Comment on Draft Report – Kentucky Utilities – Tyrone Generating Station

**Re: Kentucky Utilities' Comments for  
*DRAFT Report of Geotechnical Investigation Dam Safety Assessment of Coal Combustion Surface  
Impoundments Kentucky Utilities, a Subsidiary of E.ON U.S. Tyrone Generating Station, Tyrone, Kentucky***

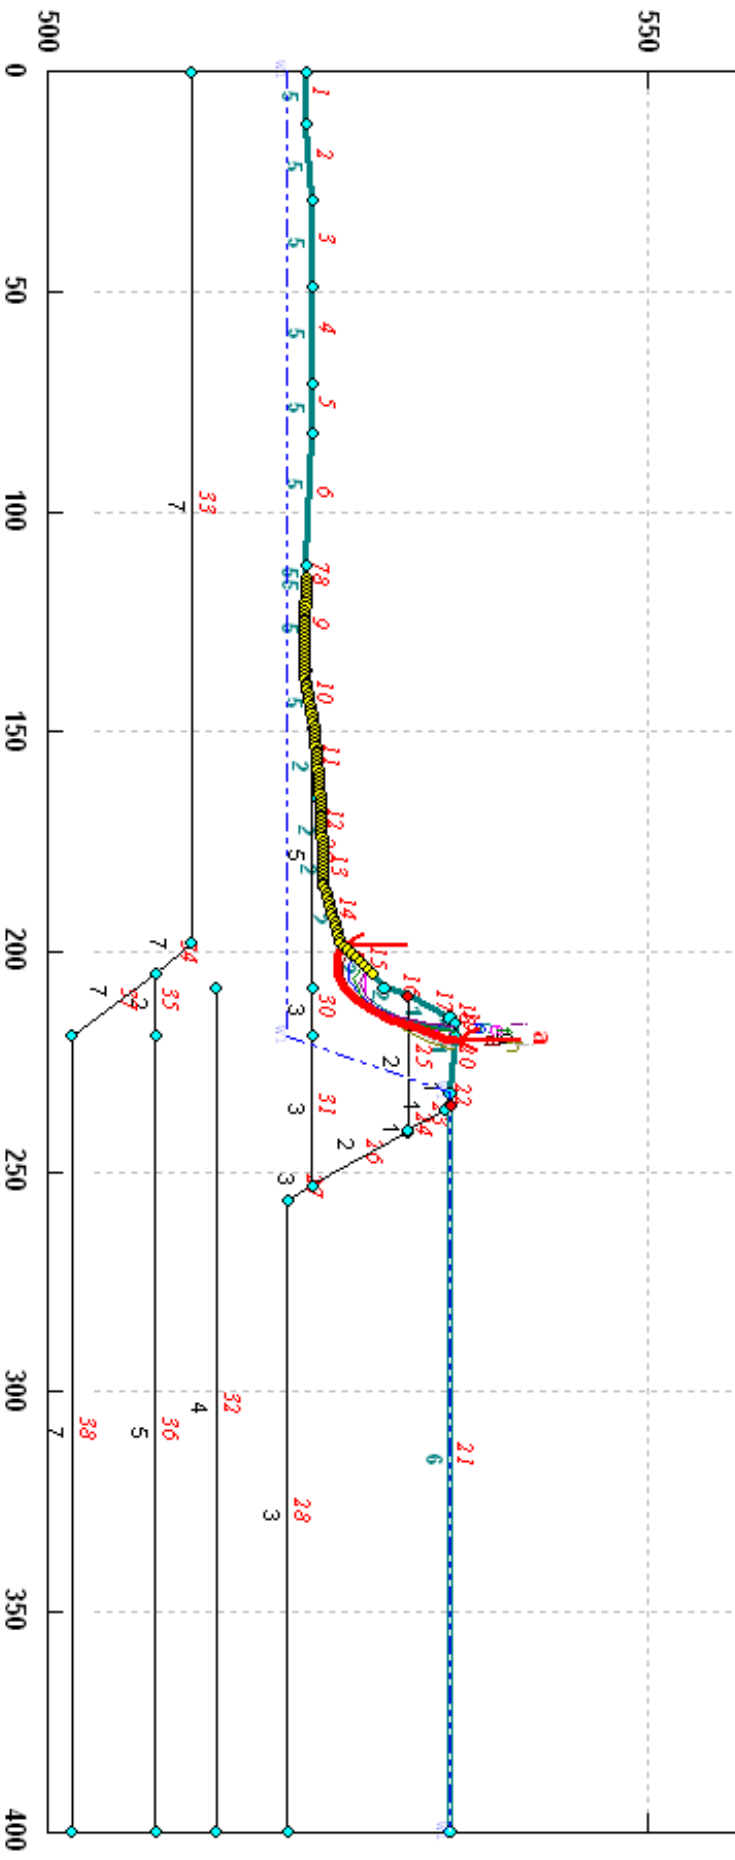
Information provided by you suggests it may be possible during normal operation of the ash pond that solids in the pond reach a maximum level near the upstream embankment crest elevation. We have performed additional stability analyses for the downstream embankment slopes for the original six cross sections that reflect this condition (i.e., “pond full”). The additional analyses are based on the Steady-State/Maximum Flood cross sections, with the modification of CCW solids extending to the upstream crest elevation. The results of the analyses are provided on the attached *Results of Slope Stability Analyses – Tyrone Power Station Ash Pond* table. In addition, the section geometry, input parameters, and stability analysis results are provided on the attached STABL6H output plots. Our

\*\* Includes CCW solids to upstream crest elevation; factor of safety against failure checked for downstream embankment face only
